Access Compliance Report

Public Rights-of-Way

Intersection ID: 10029072	Main Street: IVERSON_WY	Cross Street: N/A	Location:	N
ADA ID: 135393D93735	Ramp Type: PerpDiag	Initial Pass/Fail: Pass	Overall Compliance: No	Severity Score: 7.5
Codes/Mitigation Info/Possible Solution		Field Measurements/Component Compliance

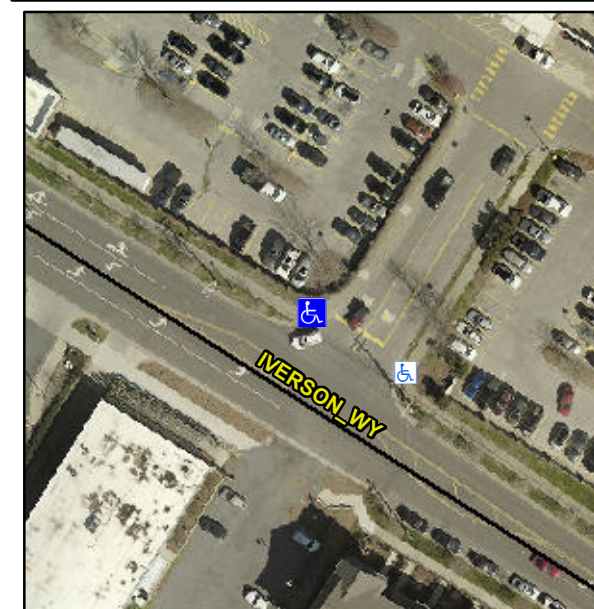
Not Found, R304.2.1, R304.2.2-Perp, R304.3.2-Para, R302.7.2

Compliance	Description	Data	Compliance	Description	Data
N/A	Ramp Length (in)	25.0	Yes	Ramp Slope (%)	5.7
Yes	Ramp Width (in)	48.0	Yes	Ramp XSlope (%)	0.1
N/A	Flare Type LT	Sloped	N/A	Flare Type RT	N/A
N/A	Flare Slope LT (%)	1.7	Yes	Flare Slope RT (%)	5.1
N/A	Flare Traversable LT?	Yes	N/A	Flare Traversable RT?	Yes
No	Landing Length (in)	42.0	Yes	DWS Provided?	Yes
Yes	Landing Width (in)	48.0	Yes	DWS Contrast?	Yes
No	Landing Slope (%)	2.3	Yes	DWS Length (in)	24.5
Yes	Landing X Slope (%)	0.6	Yes	DWS Full Width?	Yes
N/A	Landing Curb? (Y/N)	No	Yes	DWS Offset (in)	1.5
N/A	Shared Landing?	No			
Yes	Gutter Ponding?	No	Yes	Gutter Slope (%)	1.5
No	Gutter Lip Ht (in)	0.5	Yes	Gutter X Slope (%)	0.8
N/A	Painted X Walk1?	No	N/A	Painted X Walk2?	No
	X Walk 1 Direction	To SW		X Walk 2 Direction	To SE
N/A	X Walk 1 Width (in)	N/A	N/A	X Walk 2 Width (in)	N/A
	X Walk 1 Slope (%)	6.4		X Walk 2 Slope (%)	2.9
	X Walk 1 X Slope (%)	0.6		X Walk 2 X Slope (%)	0.7

Remove & Replace Curb Ramp With Two New Directional Ramps or Equivalent.
